docume		relating to or inte	nded to be used for any
Mid Continue Bublic Library		LEE'S SUMMIT LIBRARY	150 NW Oldham Parkway LEE'S SUMMIT, MO 64081 JACKSON COUNTY
			Package
	En	gineer of Re	cord
Terr	y M Parsons	, Engineer M	10 PE-2018010505
	ols	<b>5</b> 50	on
Over TEL FAX	West 133rd land Park, K 913.381.117 913.381.117 o.olsson.com	KS 66213 70 74	ite 200
Olsse Misse	on ouri State C

0.	2 /	ASI01 ASI02	06.26.21 08.30.21
Projec		Date	Drawn
	8-0330 ng No.	10.12.202	20 HMO

UTILITY PLAN pyright 2019 - Sapp Design Associates, Architects, P.C.

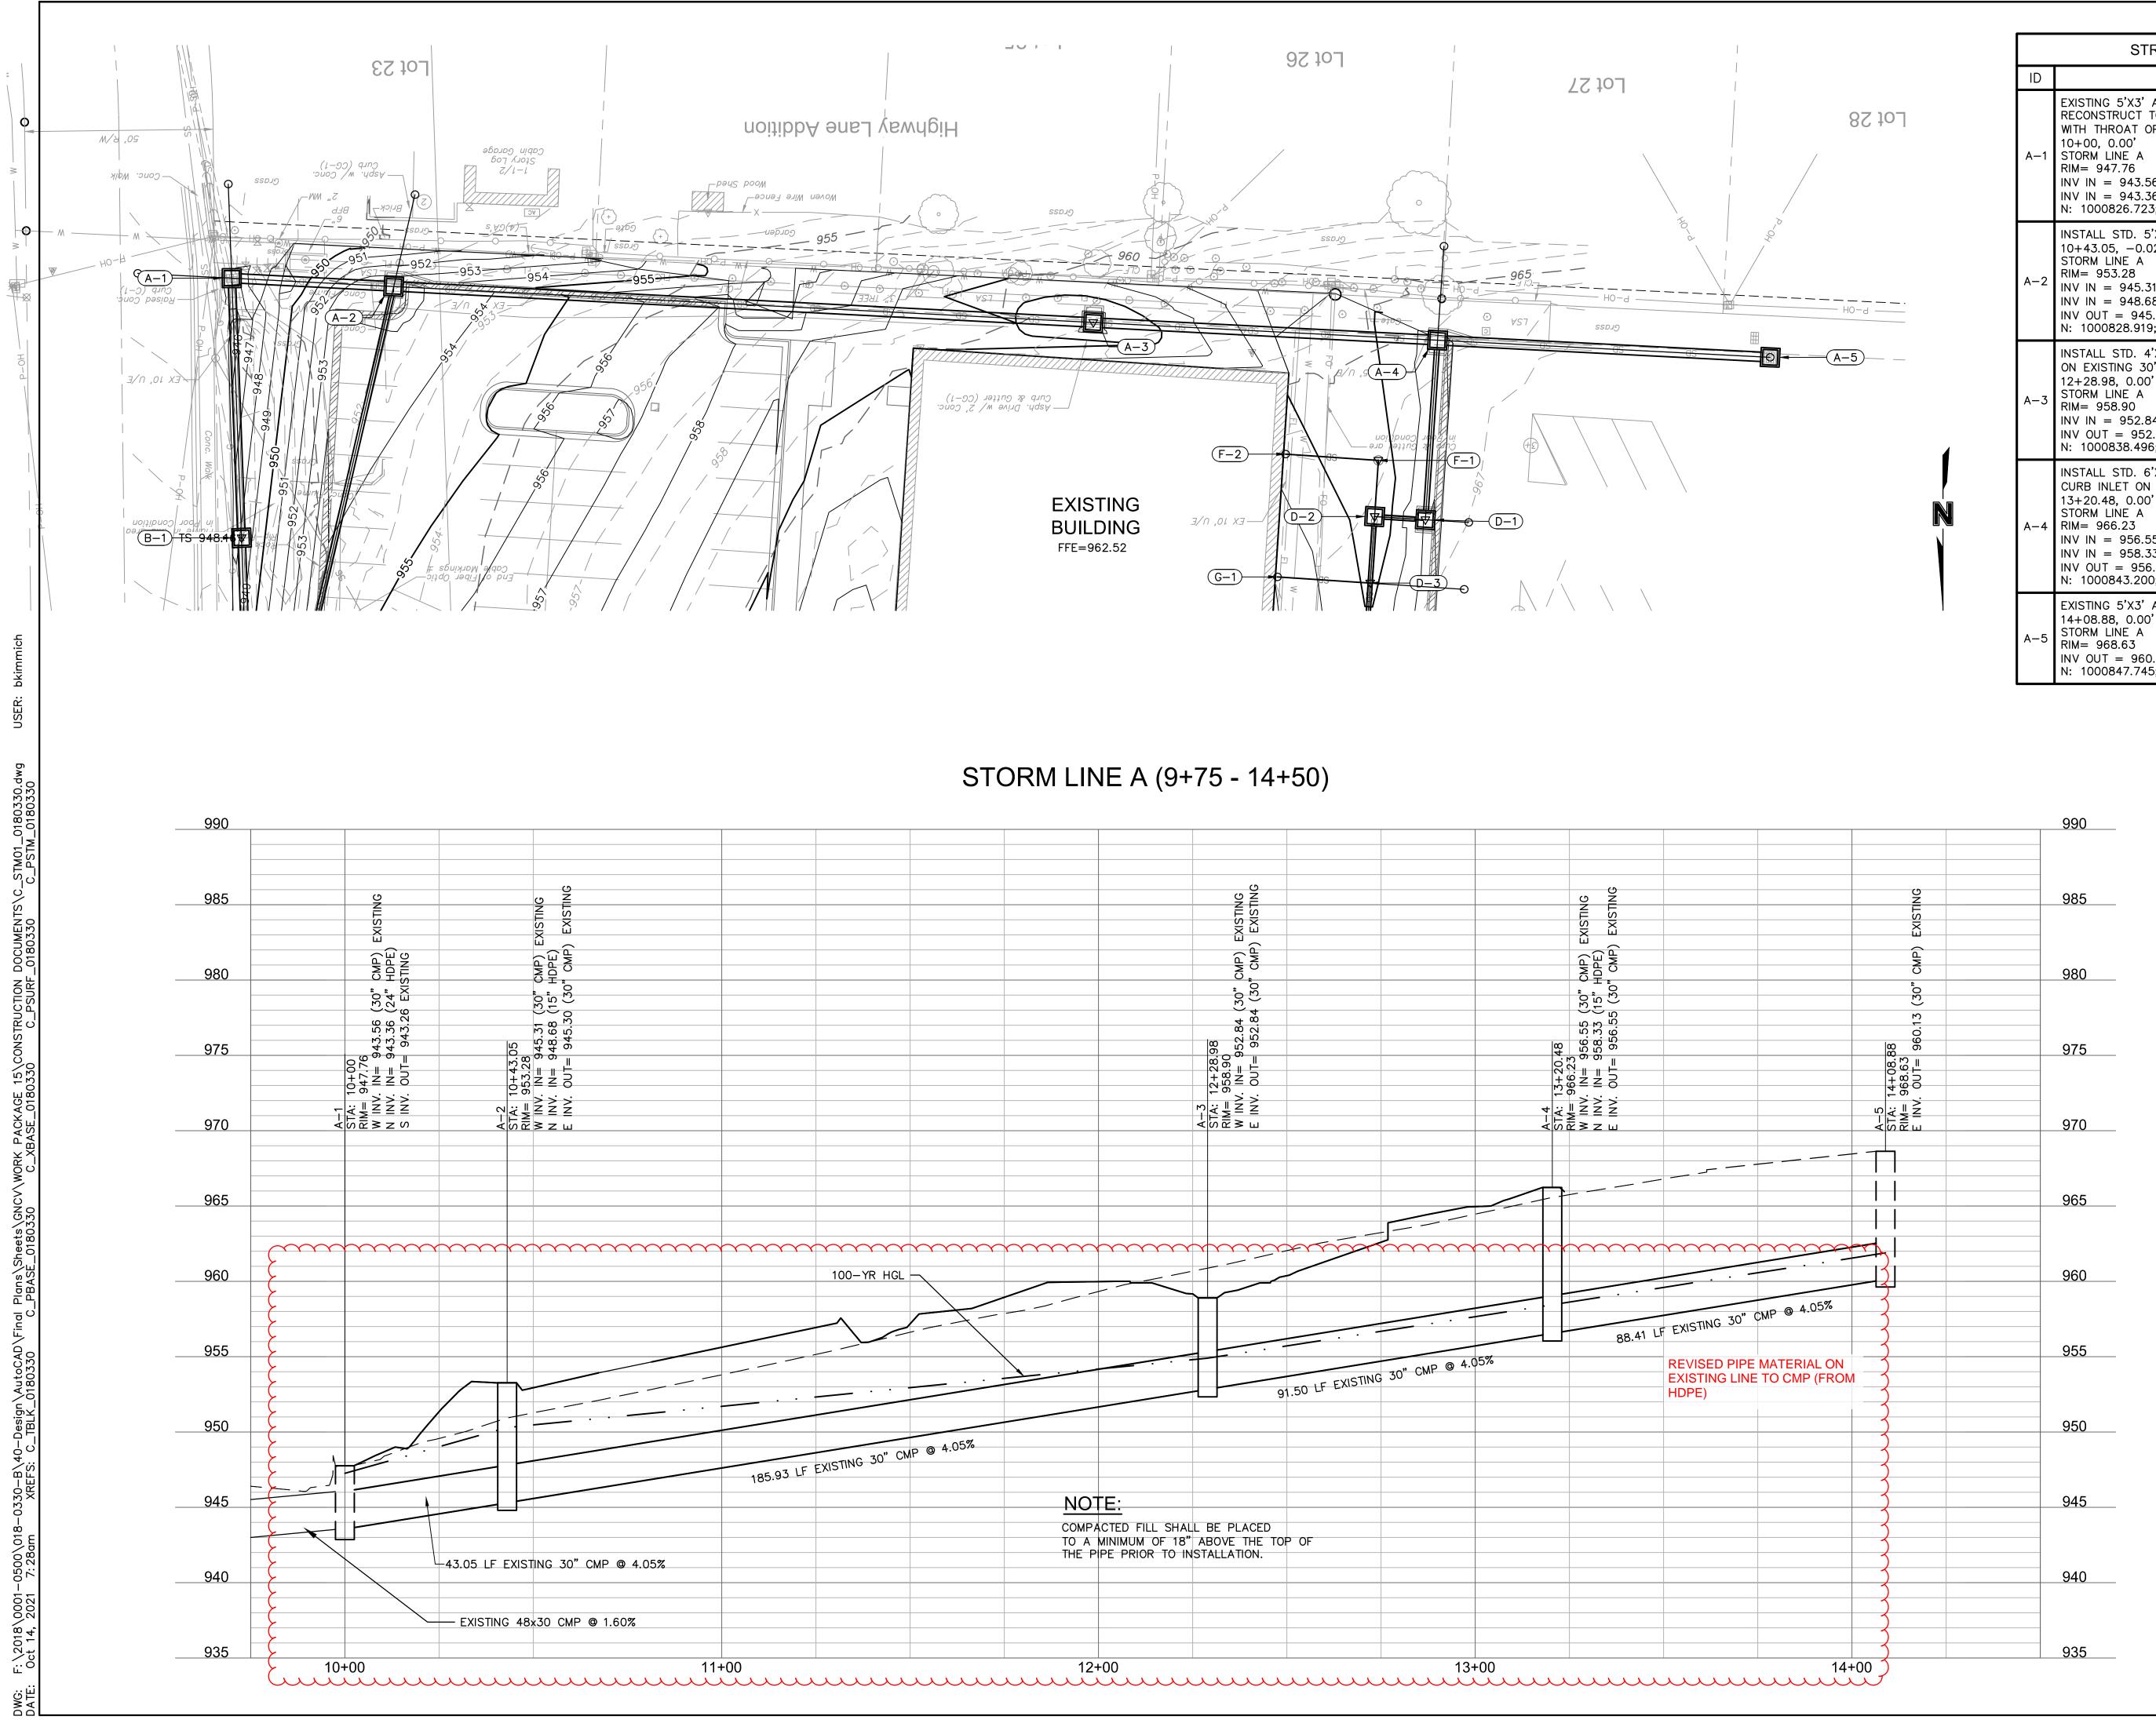
CONTRACTOR NOTE (W-2):

CONTRACTOR TO VERIFY DEPTH OF EXISTING 2" WATERLINE AT METER. 4 FT OF MINIMUM COVER IS DESIRED. IF THE DEPTH OF THE SERVICE LINE IS LESS THAN DESIRED THE CONTRACTOR SHALL NOTIFY THE ENGINEER. GRADE ADJUSTMENTS MAY BE REQUIRED TO THE METER PIT AND BFP VAULT. SEGMENTAL RETAINING WALL MAY ALSO BE REQUIRED TO PREVENT DISTURBANCE OF NEIGHBORING PROPERTY. THE CONTRACTOR SHALL CARRY AN ALLOWANCE FOR AN INCREASE OF 1' IN HEIGHT TO THE PIT AND VAULT AND 30 SF OF WALL FACE.

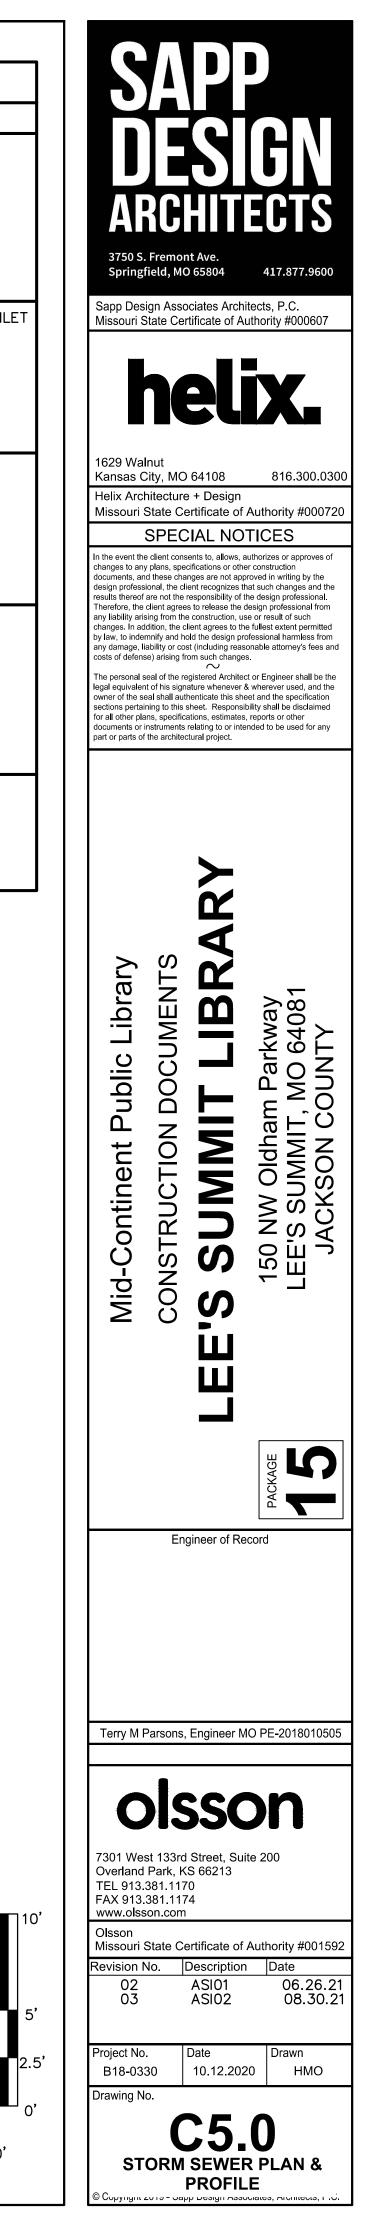
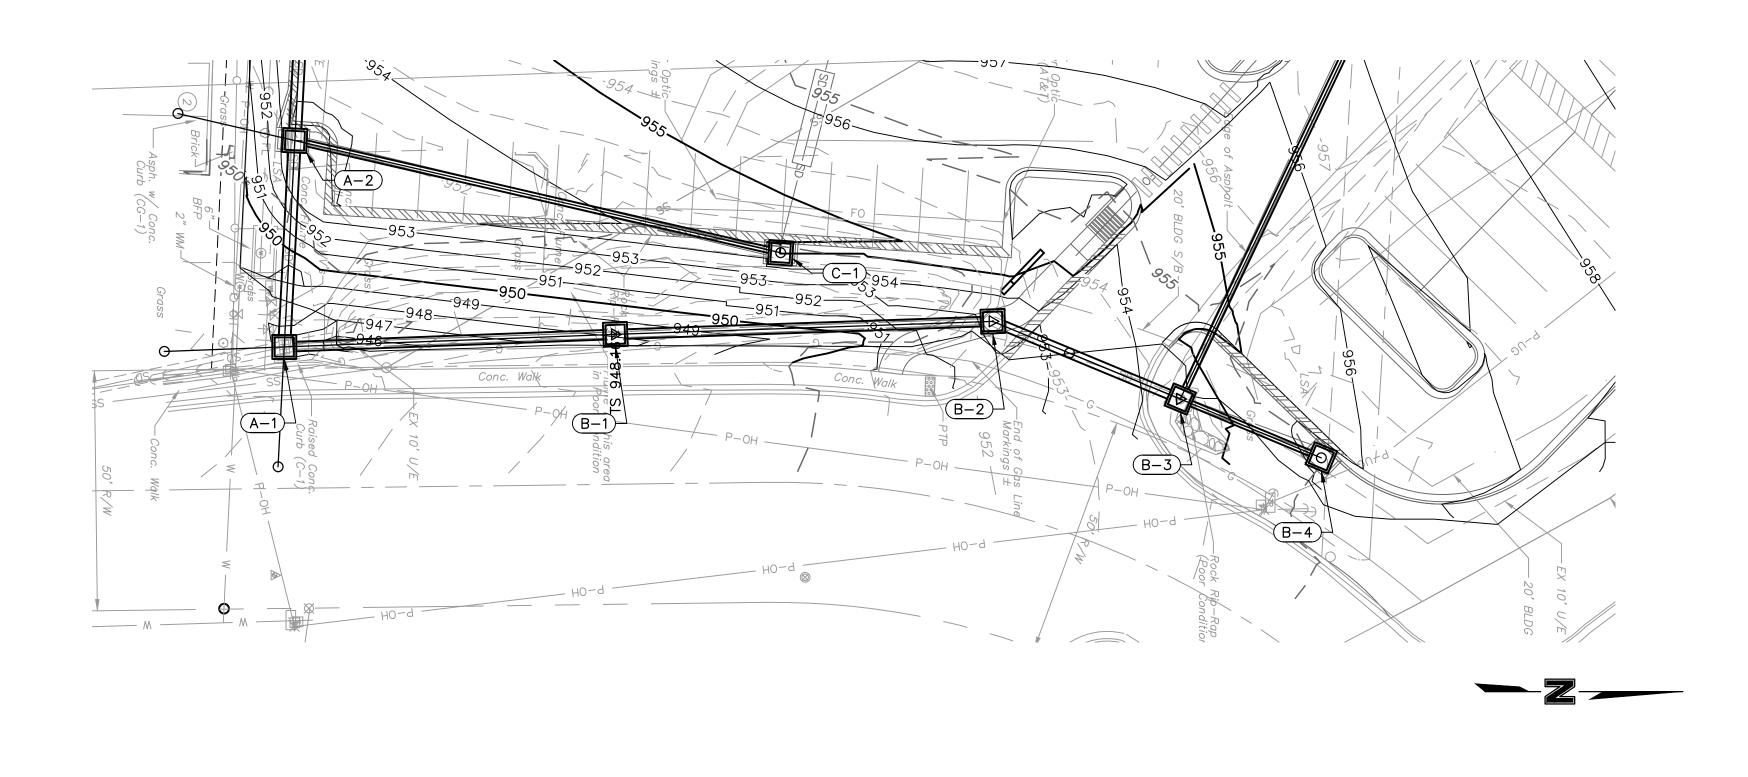
- \									88.41 LF	EXISTING 30"	
	$\backslash$											
							" OND @ 4.	05%			<b>REVISED PIPE</b>	MATERIAL
						- EVISTING	30" CMF				EXISTING LINE	TO CMP (

• • •					<u> </u>	1.50 LF EXISTING					HDPE)	, , , , , , , , , , , , , , , , , , ,
					<b>`</b>							
	P @ 4.05%											
; 30"СМ	F S											
		NO <sup>-</sup>										
		COMPA	CTED FILL SHAL	L BE F	PLACED							
		TO A	MINIMUM OF 18"	ABOVE	E THE TO	OP OF						
		THE P	IPE PRIOR TO IN	STALLA	ATION.							
								1				
			+00					+00				
JJJ	uu	uuu	uuu	J	LLL	m	uu	<u> </u>		uuu	m	····
